HARBOUR ISLAND MASTER HOME OWNERS ASSOCIATION ARCHITECTURAL AND ENVIRONMENTAL COMMITTEE (ARCHCOM)

SAN ANTONIO PRECINCT , HARBOUR ISLAND

Amendments to Architectural Guidelines

BALCONY ENCLOSURES

TYPICAL FLOOR PLAN

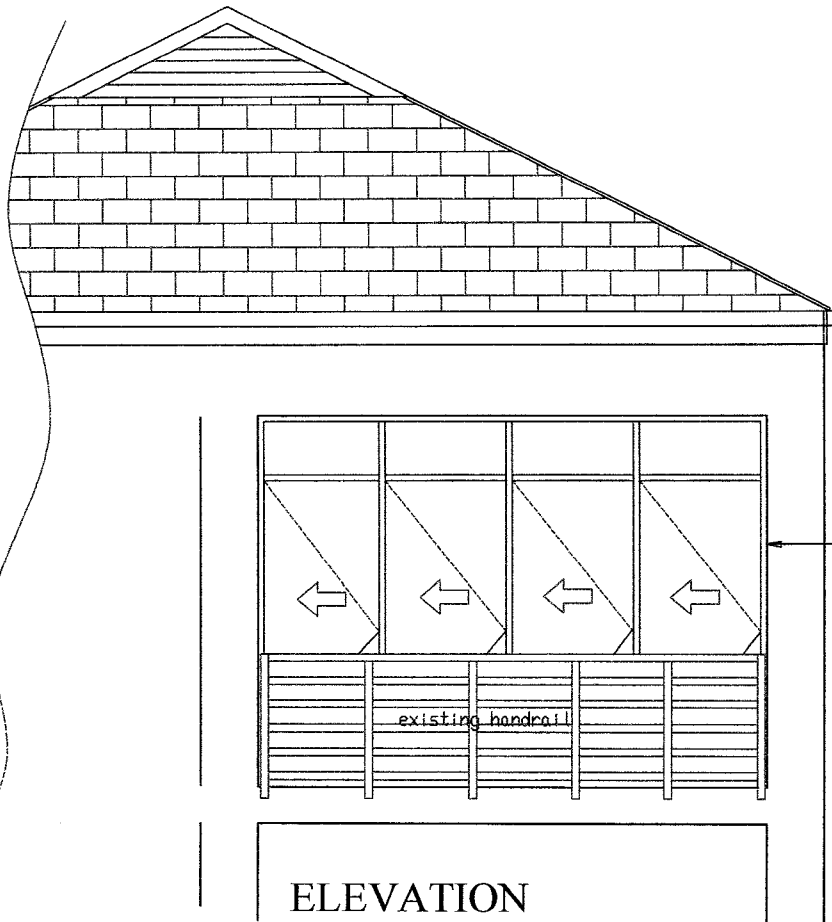
Balcony enclosures will be permitted with the consent of the San Antonio Trustees and the Harbour Island ARCHOM committee and are to be subject to the following restrictions:

- 1) The enclosures are to be formed with sliding folding doors constructed in aluminium, powder coated white in the same format as the existing balcony doors and windows as shown on the accompanying sketch.
- 2) No curtains or blinds will be permitted on the enclosed balcony.
- 3) Sufficient space must be left between the doors and the existing handrail to permit cleaning and maintenance to be carried out, so the doors must be mounted towards the inner edge of the 380 mm columns.
- 4) Drawings must be submitted for approval before manufacturing or construction takes place. There are variations to the situation shown on the sketch and each will be dealt with by the committee on receipt of the drawings when submitted for approval.

Aluminium sliding folding doors with toplights
Glazing to doors & windows in excess of 1
sq. meter or less than 300mm above
finished floor level to be safety glazing in
accordance with Building Regulations Part N.

TYPICAL FOLDING DOOR ELEVATION

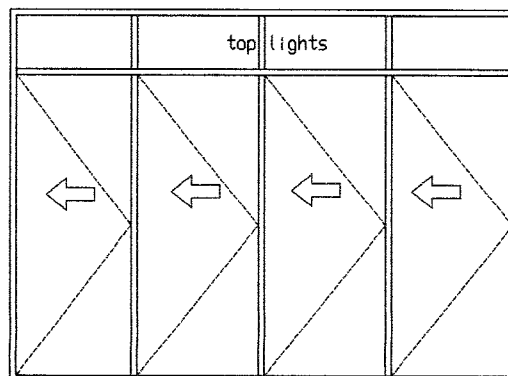
Aluminium sliding folding doors with toplights
Glazing to doors & windows in excess of 1
sq. meter or less than 300mm above
finished floor level to be safety glazing in
accordance with Building Regulations Part N.
